Commonwealth Edison
One First National Plaza, Chicago, Illinois
Address Reply to Post Office Box 767
Chicago, Illinois 60690

September 25, 1984

Subject: Byron Generating Station Units 1 and 2
Byproduct Material License No. 12-05650-18
NRC Docket Nos. 50-454 and 50-455

Proposed Change to Byron Byproduct Materials
License 12-05650-18

DRAWING 4
PRIMARY SOURCE DRY STORAGE AREA

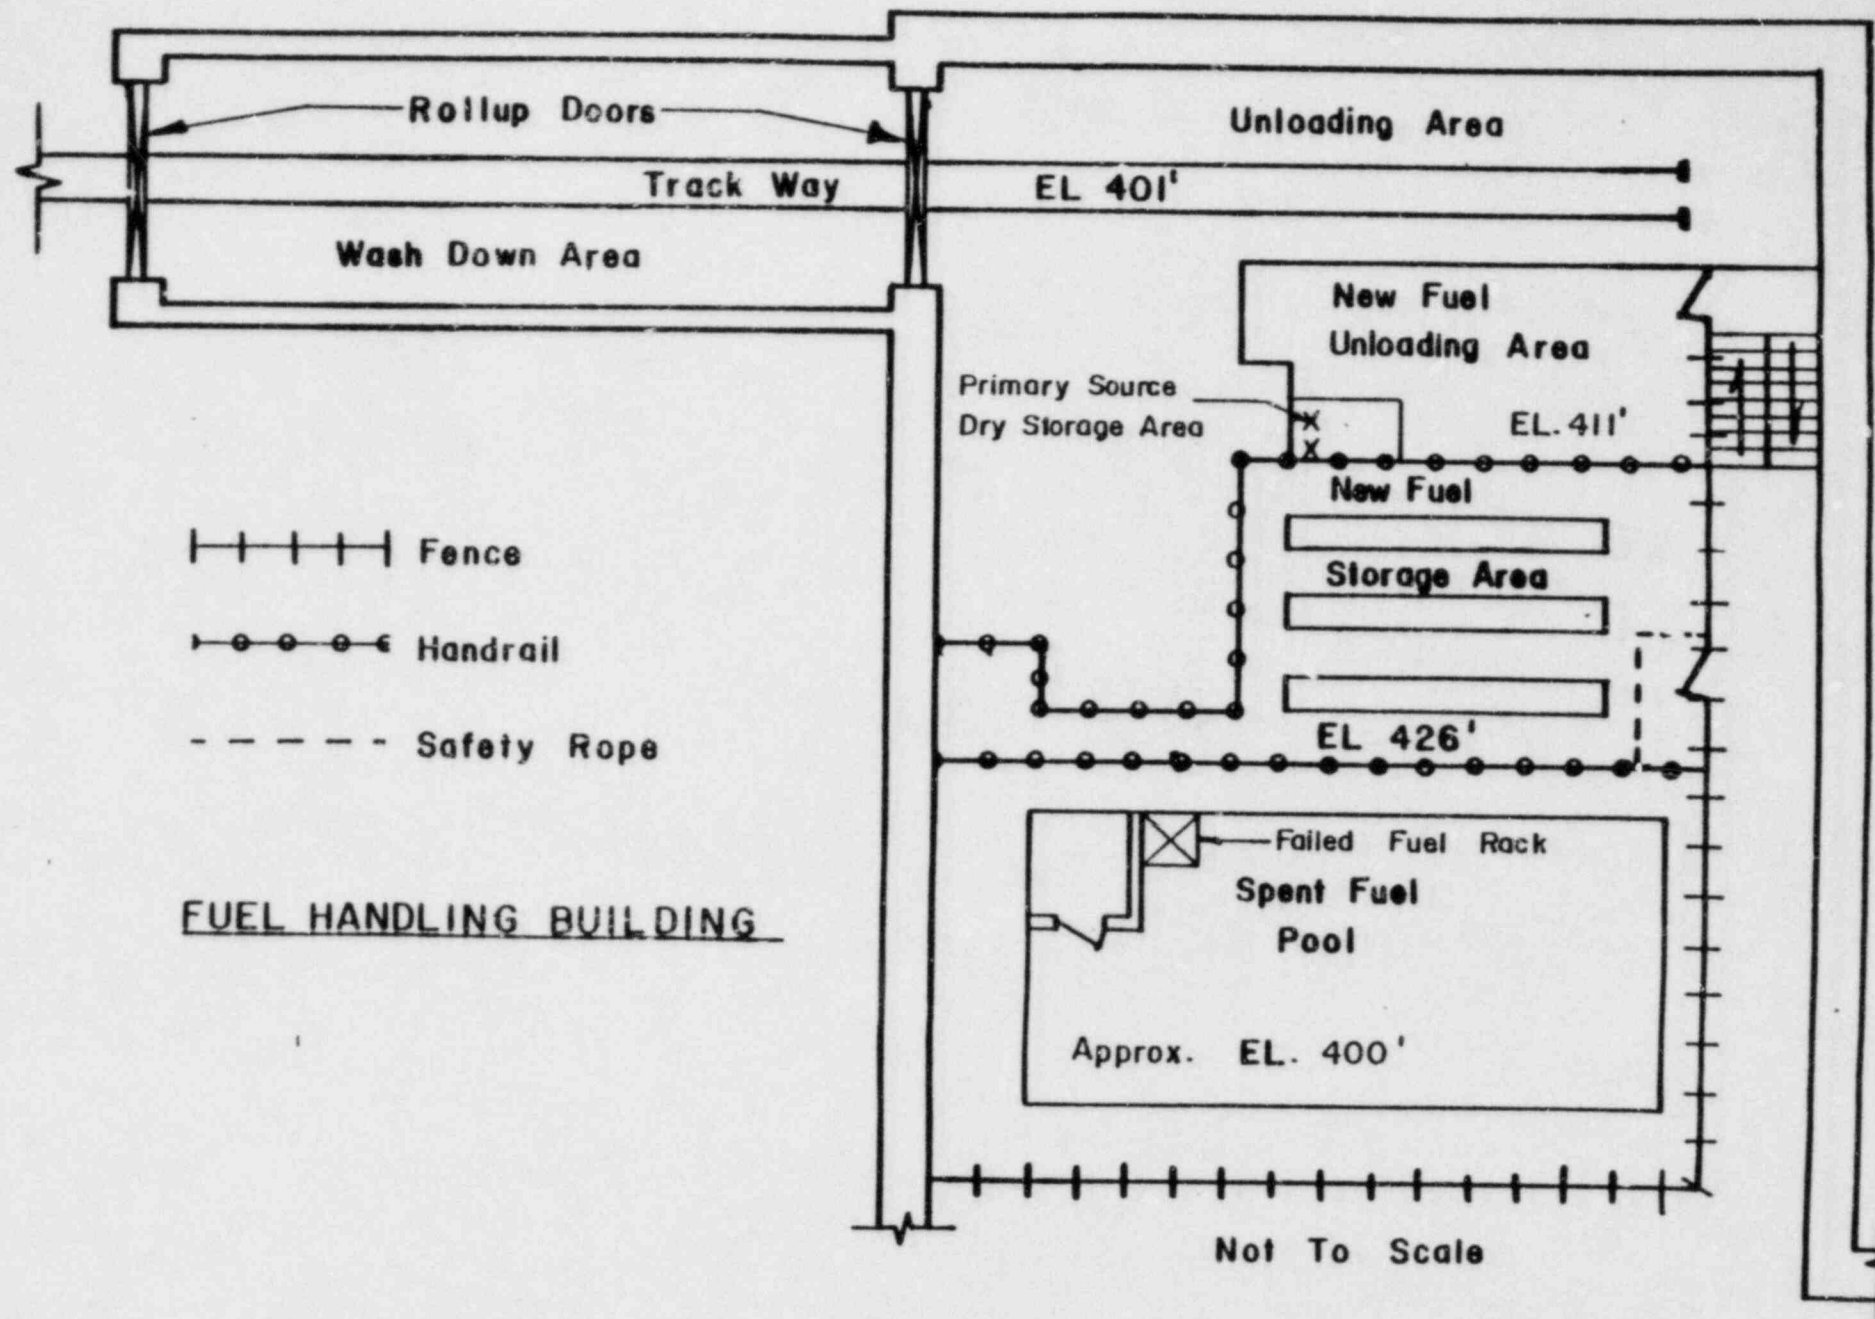
The primary neutron sources are currently stored on the 411' elevation in the Fuel Handling Building (see Drawing #3). They are individually stored inside 1 inch diameter stainless steel pipes for mechanical support and protection. The source material is located in a 1 1/2 inch long section of the 12 foot long rod approximately 33 inches up from the bottom. Surrounding the steel pipes, in the vicinity of the sources, are cylindrical shields made of paraffin and borated concrete. Surrounding the pipes and containers is a concrete block wall approximately 4 feet high (see Drawing #4). This area has been thoroughly surveyed and is appropriately posted and surveilled.

For storage only in either a dry, protected storage area or in a new fuel assembly located in borated water in a failed fuel container.

CONSTRUCTION
DRAWING

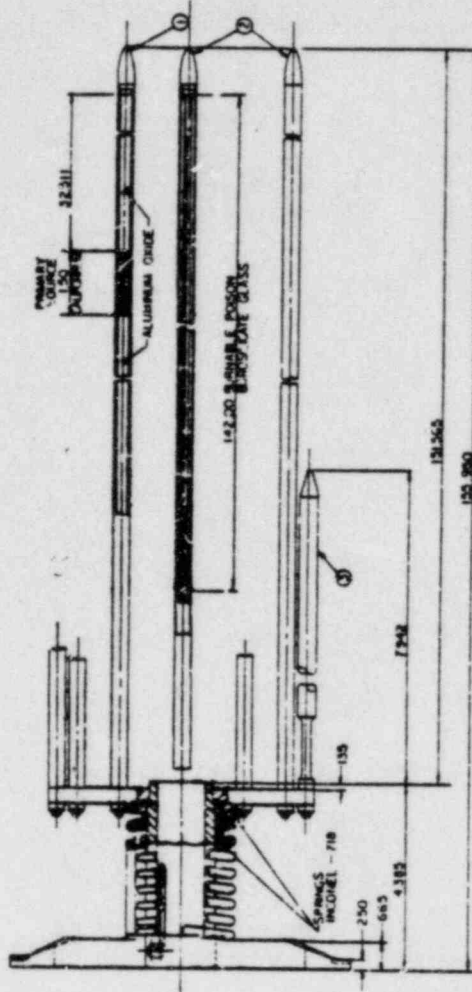
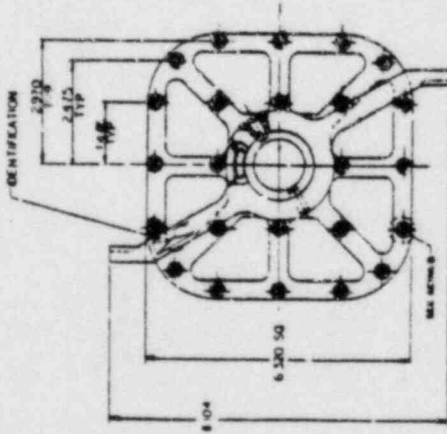
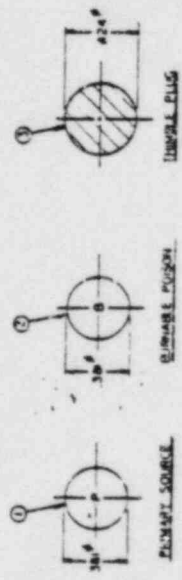
Transfer of the source rods will be controlled by a written procedure. The source rod will be withdrawn, by hand, from its current storage container into a support assembly and secured. Leak test swipes will be taken during this operation. The source rod and support assembly will be lifted by the fuel handling building overhead crane across the top of the new fuel vault and inserted into the center failed fuel container (see Drawing #3). In this water shielded condition, a person will approach the source and detach the source and support assembly from the crane. This person will then attach the end of the source rod itself to a line extending up to the spent fuel pit bridge crane. After this person withdraws from the area, another person on the bridge crane will manually extract the rod and insert it into the appropriate fuel assembly with the help of a guide funnel. Once inserted in the fuel assembly it will again be water shielded and may be safely approached. The burnable poison rod assembly (BPRA) will then be reinserted into the fuel assembly and the source rod secured to the BPRA with a nut on the threaded source rod end. A lock wire will then be tack welded to the nut to prevent the nut from loosening (see Drawing #5).

FIGURE 9.1-2

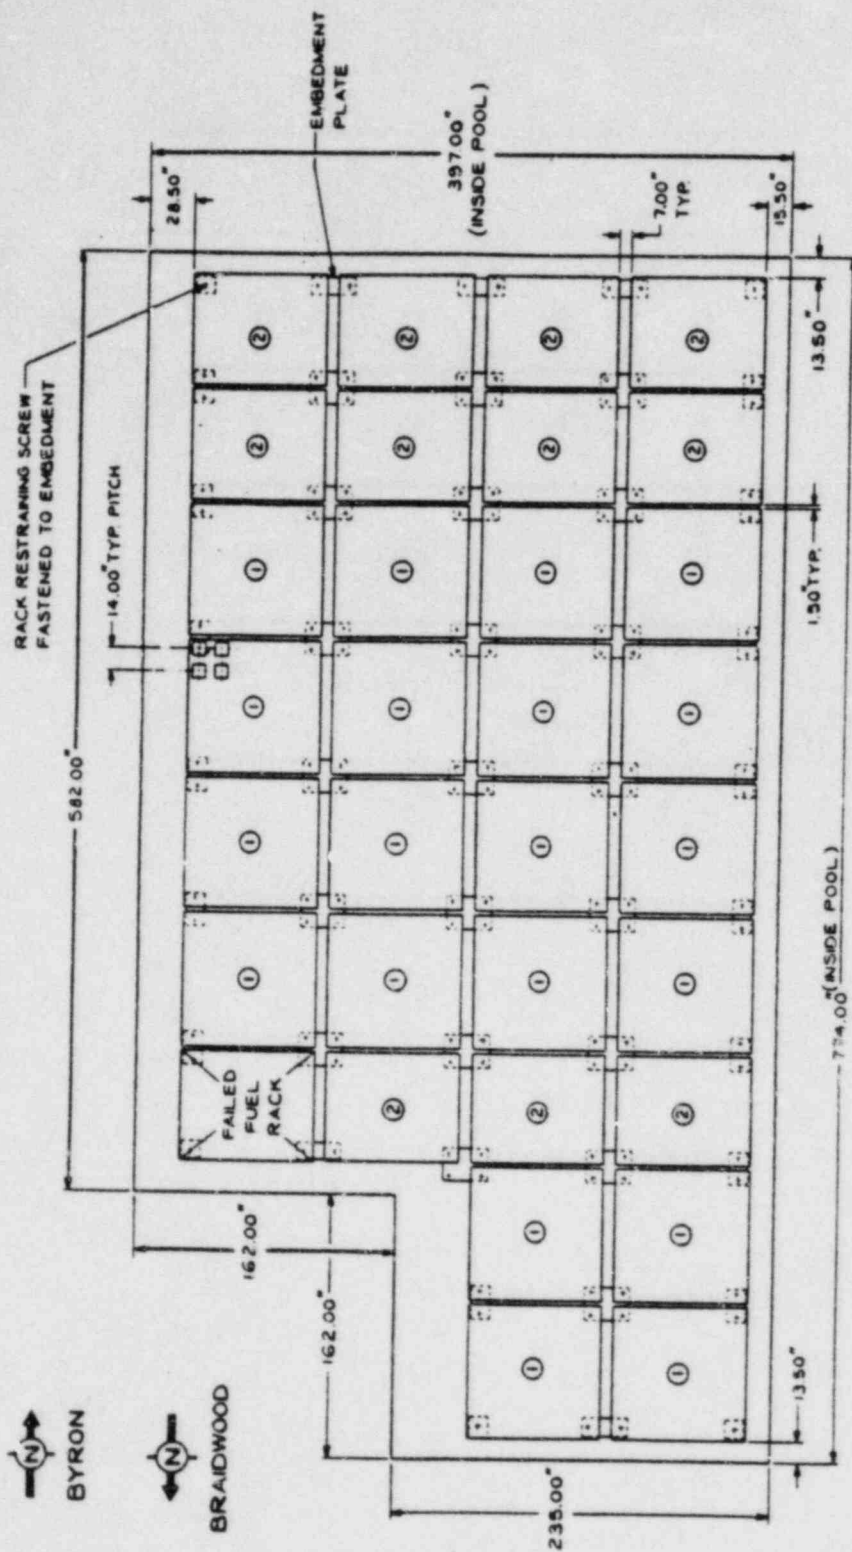
The proposed storage location for each source rod is attached to a Burnable Poison Rod Assembly located in a new fuel assembly (see Drawing #5). The fuel assemblies are stored in borated water shielding inside failed fuel containers (see Drawing #2). The failed fuel containers (see Drawing #1) are cylindrical vessels approximately 13 inches in diameter containing a internal fuel assembly support framework. The failed fuel containers are stored in pipes approximately 15 inches in diameter which make up the failed fuel container storage rack (see FSAR Figure 9.1-4 and Drawing #2). The failed fuel rack is located in the Spent Fuel Pool (see FSAR Figure 9.1.2).
